APPLICATION NO.	FILING DATE	FIRST NAMED INVENTOR	ATTORNEY DOCKET NO.	CONFIRMATION NO.
10/588,536	08/07/2006	Fernando Garofoli	06170-PCT-PA (0030.0567)	9569
7590	08/06/2008	Armstrong Westerman and Hattori 502 Washington Avenue Suite 220 Towson, MD 21204	EXAMINER FULTON, KRISTINA ROSE	
ART UNIT	PAPER NUMBER		3673	
MAIL DATE	DELIVERY MODE			
08/06/2008	PAPER

Office Action Summary	Application No. 10/588,536	Applicant(s) GAROFOLI, FERNANDO
	Examiner KRISTINA FULTON	Art Unit 3673

DETAILED ACTION

Fig. 2

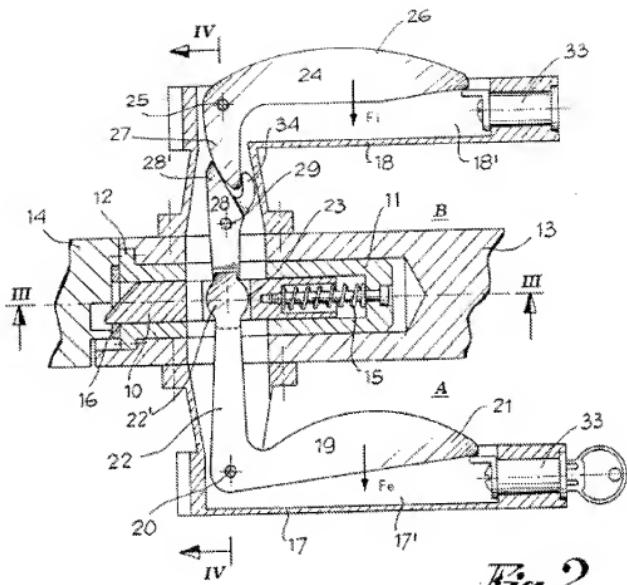
Claims 1-15 are rejected under 35 U.S.C. 102(b) as being anticipated by Pedersoli (DE4009764). "As best understood" Pedersoli shows internal and external handles (17 and 18) having an opening lever (22 or 27) and an opening button (26 or 21). The handle further include a vertical lever (28) having a fork (29). The device includes a spring (15) within a housing (11) and a latch mechanism (10). The door handle further shows a cylindrical chamber (at each end of handle for cylinder 33). The handle includes a cylinder (33) for locking the handle with a key (see illustration below). The handle is an L shape. See the Pedersoli device below.
